# **SUPPLEMENT to the CARRIZO ENERGY SOLAR FARM APPLICATION for CERTIFICATION**

**APPLICATION FOR CERTIFICATION (07-AFC-8)  
Carrizo Energy Solar Farm  
Carrizo Energy, LLC**

**Submitted by:  
Carrizo Energy, LLC**

**July 2008**

PROJECT LAYOUT  
CARRIZO ENERGY SOLAR FARM (CESF)

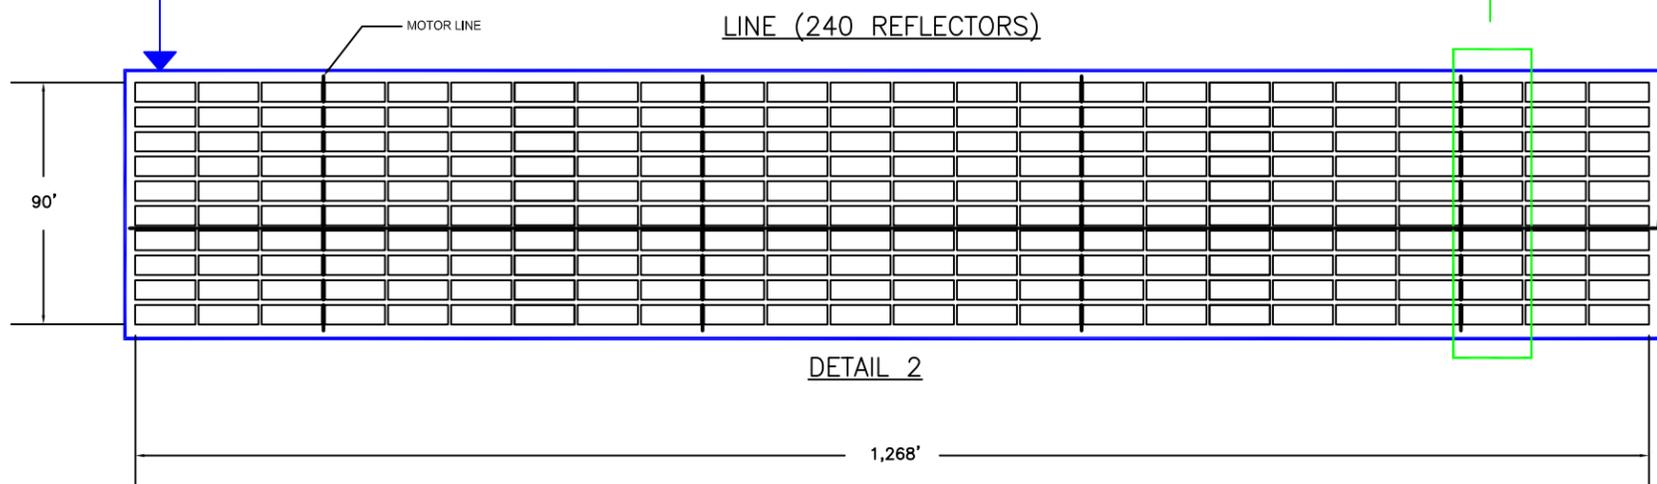
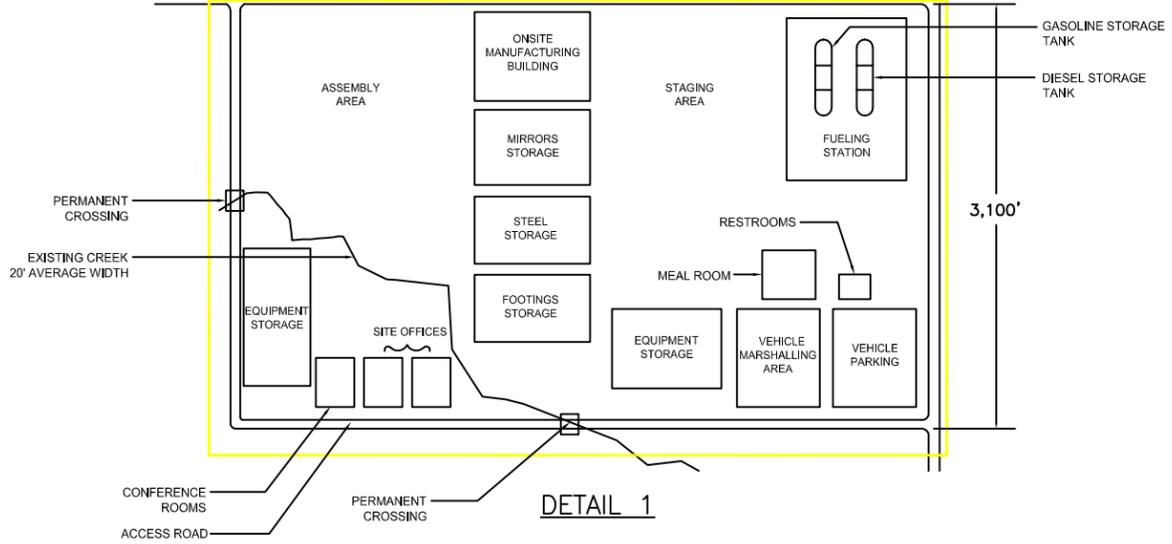
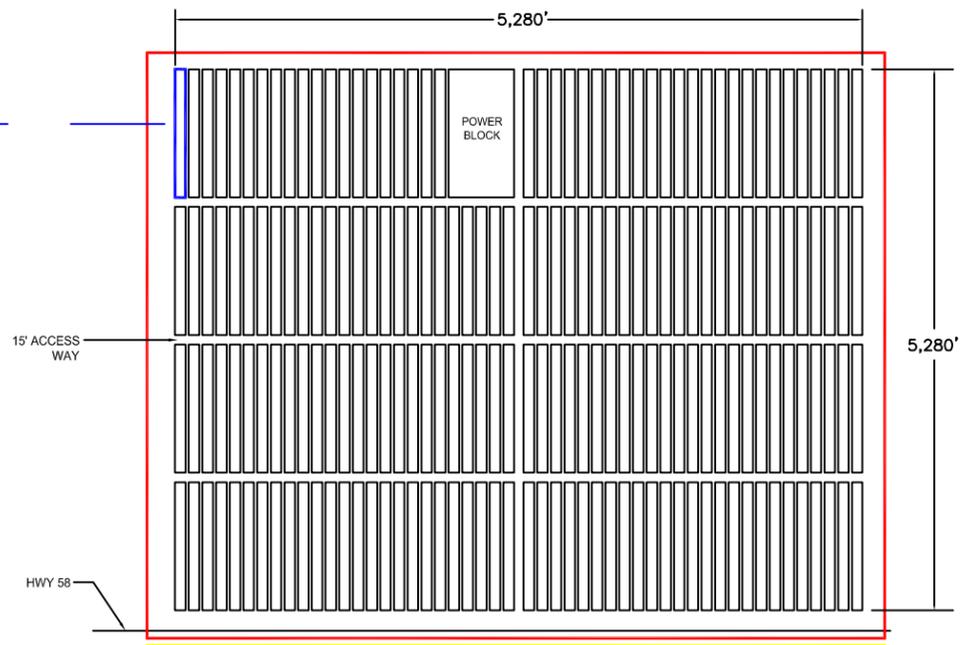
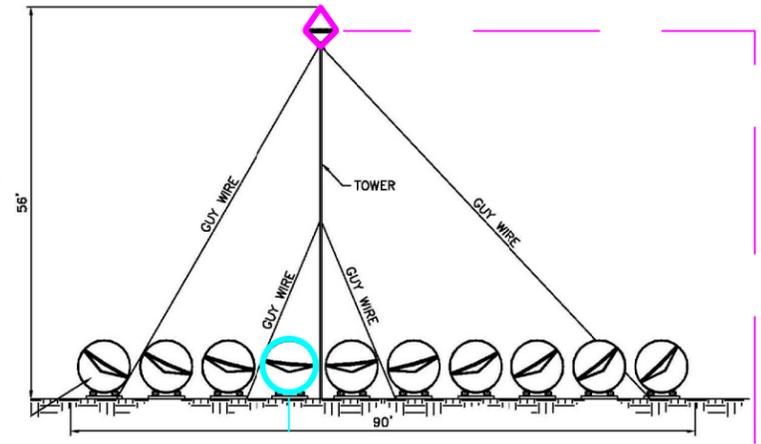
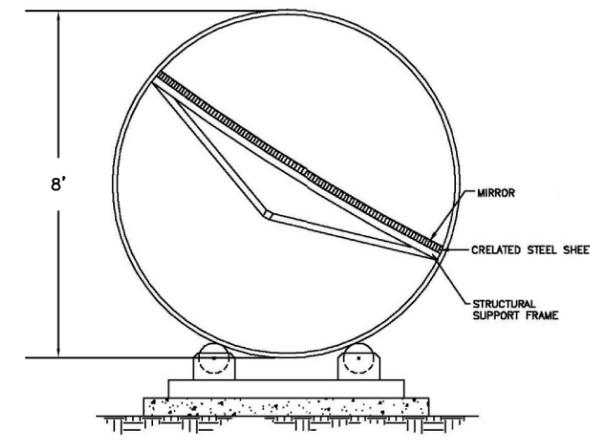
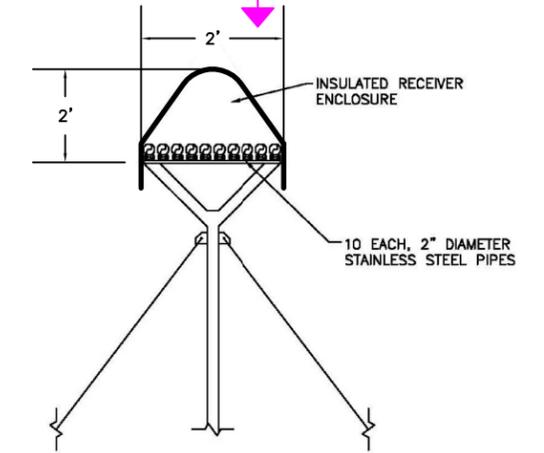
The Project will include limited onsite manufacturing in the north-central portion of the construction laydown area, located on Section 33 (Figure 1.4-1), during the construction phase of the Project. The construction laydown area originally depicted on Figure 1.1-4 in the Project AFC was rearranged to accommodate onsite manufacturing. Limited onsite manufacturing will reduce truck trips to the site during construction.

CREATED BY: JN    DATE: 06-30-08    FIG. NO:  
 PM: AL    PROJ. NO: 22239472    1.5-1

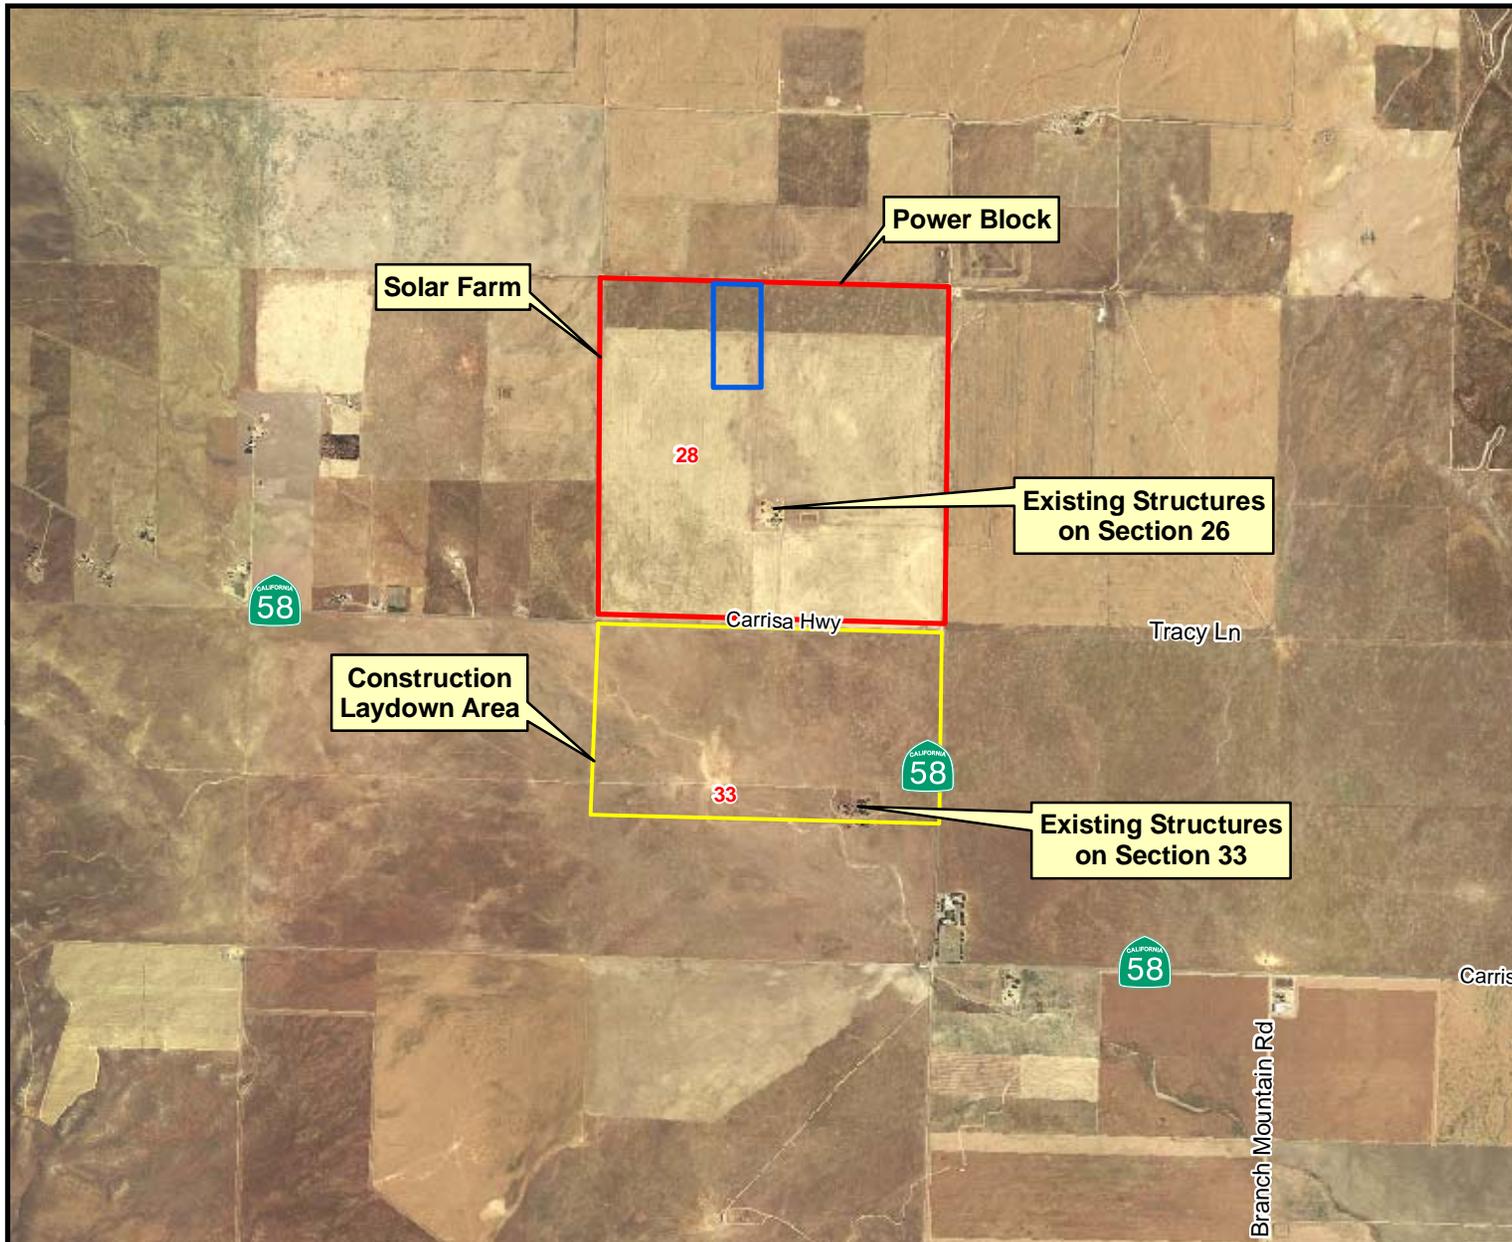
Existing structures are associated with the King property on Section 28 and the Cavanaugh property on Section 33 (Figure 1.5-1). Structures on Section 28 include a residence, barn, garage, storage shed, several cylindrical water storage tanks and silos, foundations, and smaller related agricultural, ranching, and farming buildings and structures. Structures on Section 33 include three residential structures, barns and sheds, several cylindrical water storage tanks and silos, and smaller related agricultural, ranching, and farming buildings and structures.

**CONCEPTUAL ONE LINE**  
**CARRIZO ENERGY SOLAR FARM (CESF)**

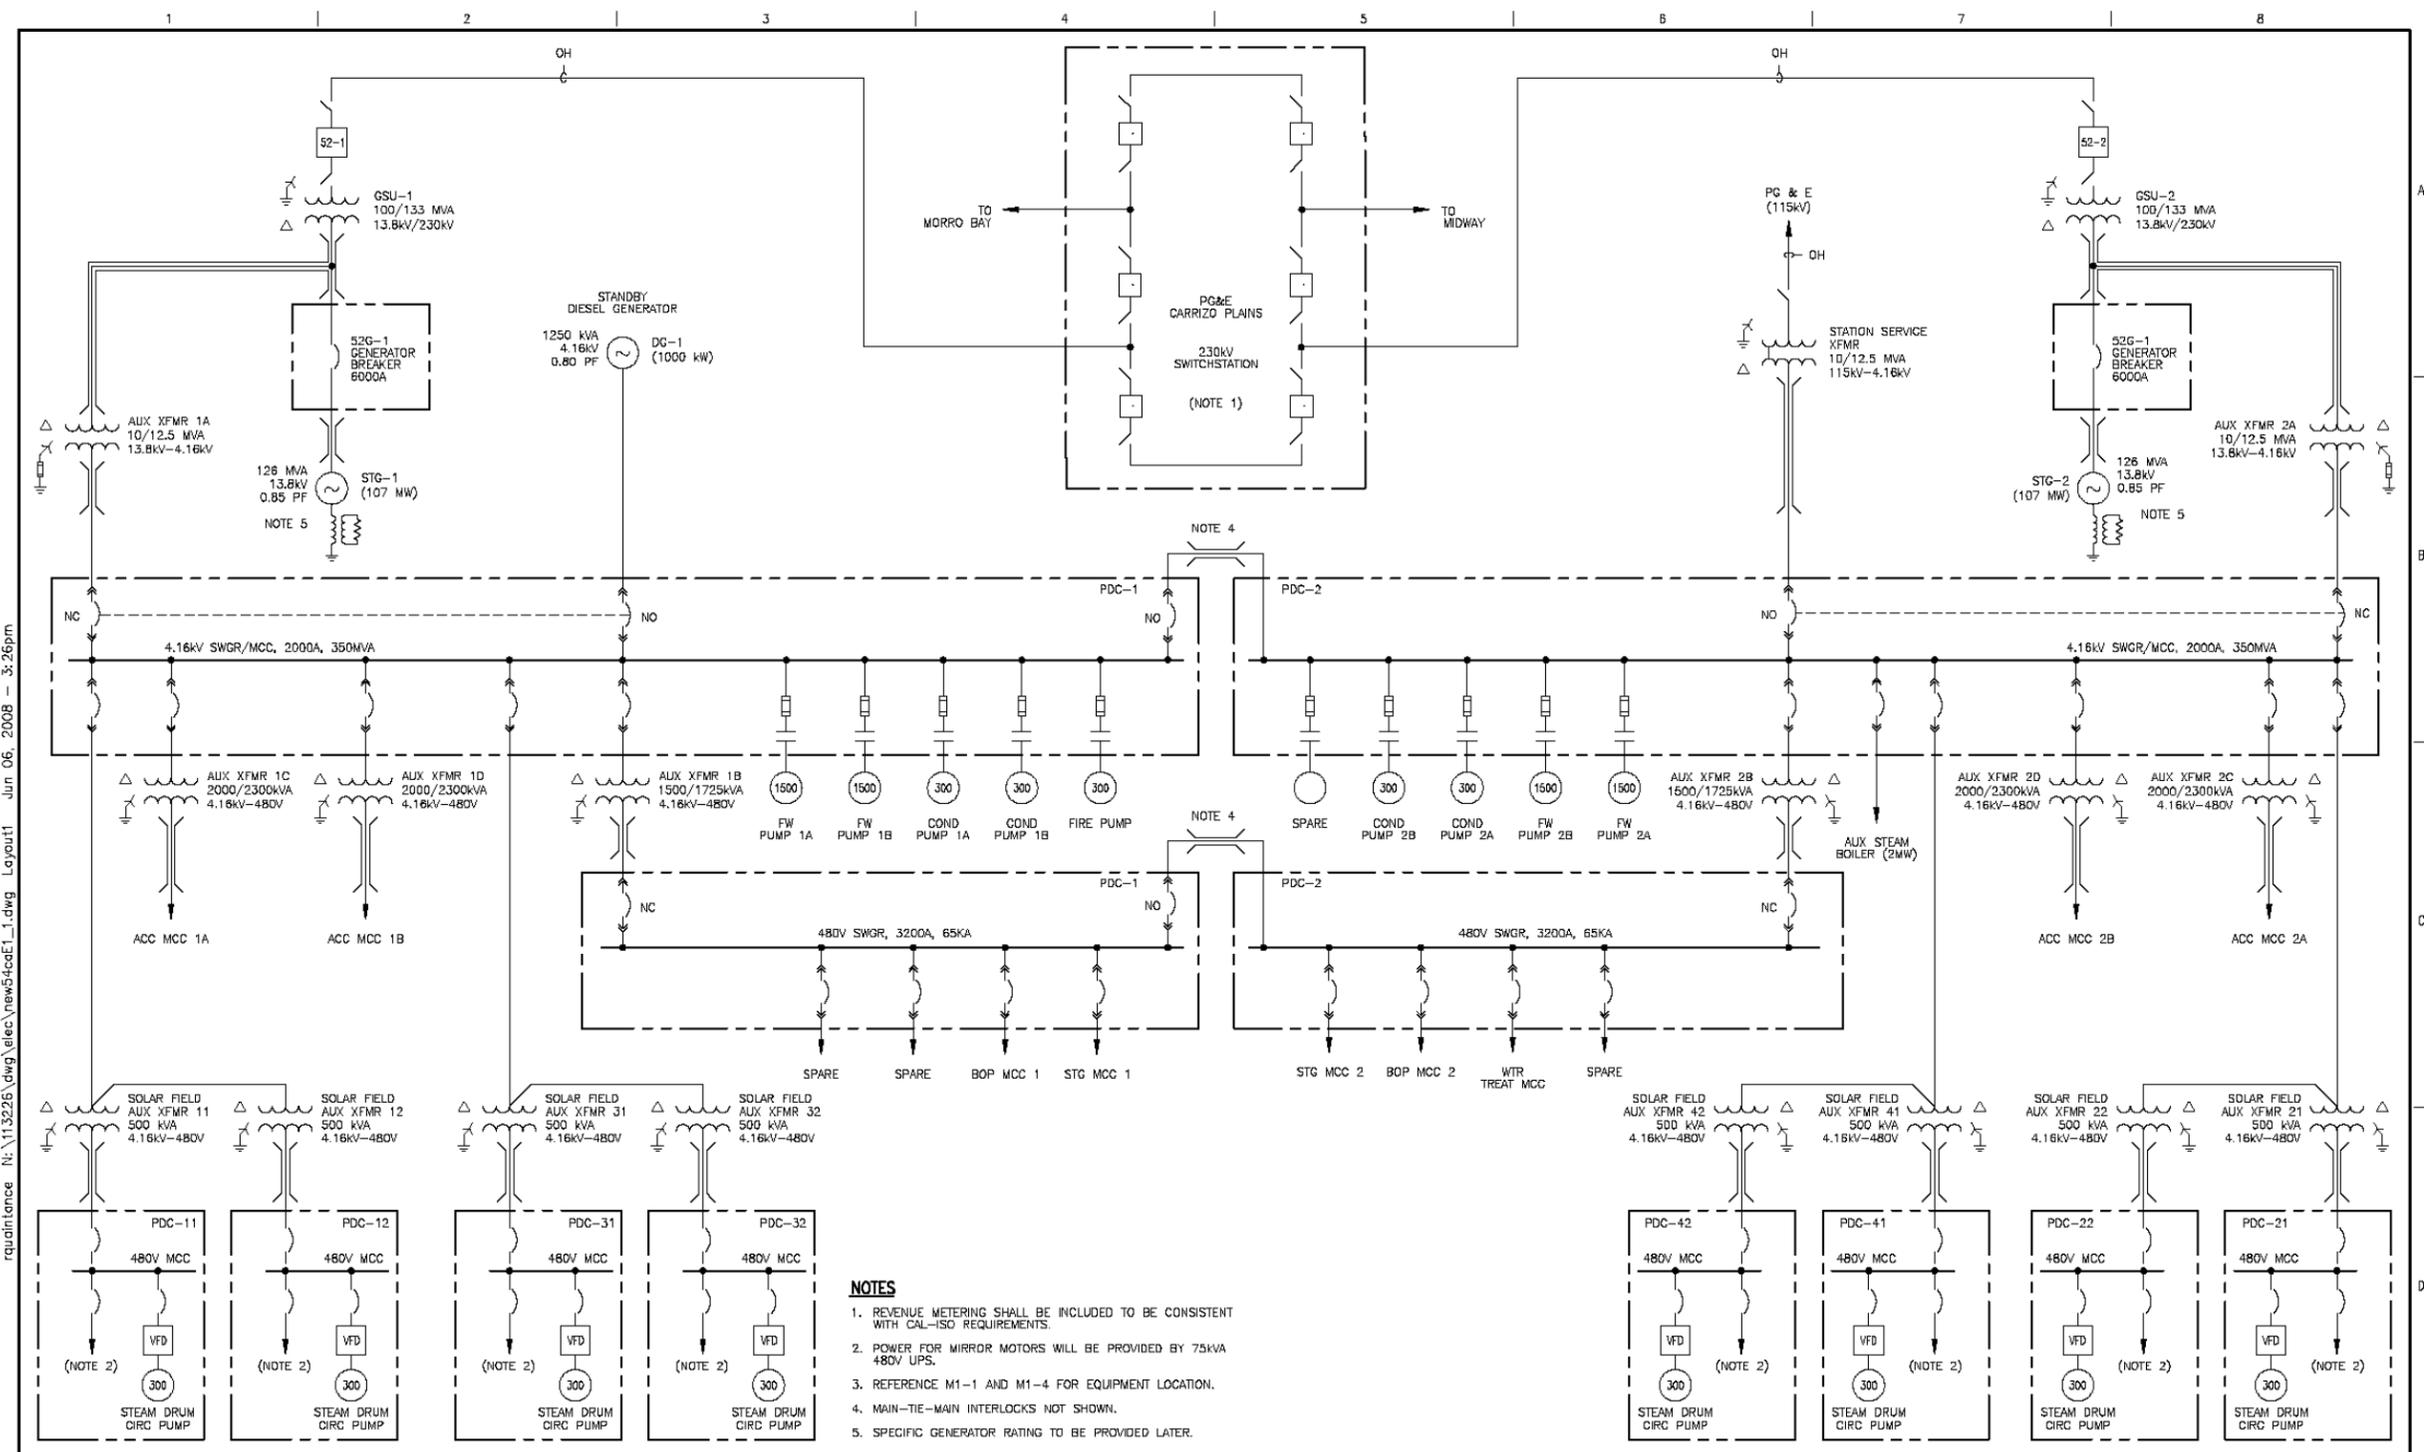
The ISIS also identified that a loop type interconnection would be required versus the tap connection proposed in the Project AFC. This looping interconnection would take place at a new PG&E 230kV Carrizo Plains Switching Station. As described in the ISIS, the 230kV transmission line from the CESF would interconnect to the Morro Bay–Midway #1 circuit through the new switchyard. The electrical interconnection has been revised accordingly and a preliminary configuration is shown on the Project single diagram in Figure 1.6-1. See also Figures 1.6-2 and 1.6-3.

unavailable due to an event on the line, or maintenance activities. This station service connection is shown on the Project single diagram in Figure 1.6-1.

The Project AFC contains a description of the solar field 480V electrical distribution system; however, per this supplemental filing, the distribution system has been altered. The revised electrical interconnection is shown on the Project single diagram in Figure 1.6-1.
